**Draft Response to Submissions Report on Berrima Colliery MP 10_0172 and
Berrima Cement Works DA No 401-11-2002-i MOD 6**

RESPONSE TO SUBMISSIONS BERRIMA COLLIERY CONTINUED OPERATIONS (MP 10_0172) AND BERRIMA CEMENT WORKS DA NO 401-11-2002-i MOD 6

OFFICE OF ENVIRONMENT AND HERITAGE - REVIEW OF RESPONSE TO SUBMISSION

**SUBJECT: RESPONSE TO SUBMISSIONS BERRIMA COAL PROJECT APPLICATION
NUMBER MP10_0172**

Photo 1: Wind Blown Dust from the Loch Catherine Stockpile Area

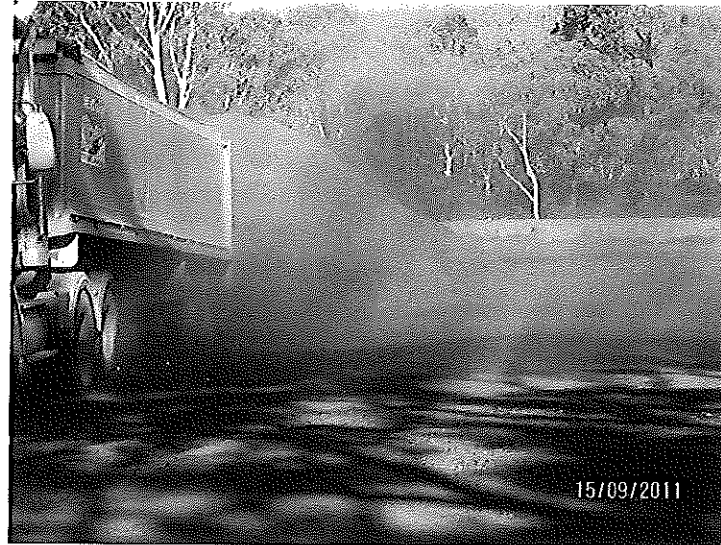
The Submissions Report states that air quality impacts associated with activities from the mine was identified as an issue in a number of public submissions. Since OEH's submission on the EA, OEH has received a number of community complaints regarding dust from road transport of coal. While during a recent site inspection on 15 September 2011 at the Loch Catherine Stockpile Area considerable wind blown dust and dusts associated with road haulage activities was observed. (See Photos 1 and 2).

In this regard, OEH recommends that a real time monitoring system should be implemented that assesses the performance of dust management measures at the site and associated road haulage activities. Such a system should also be used to guide the implementation of both reactive and proactive dust mitigation measures.
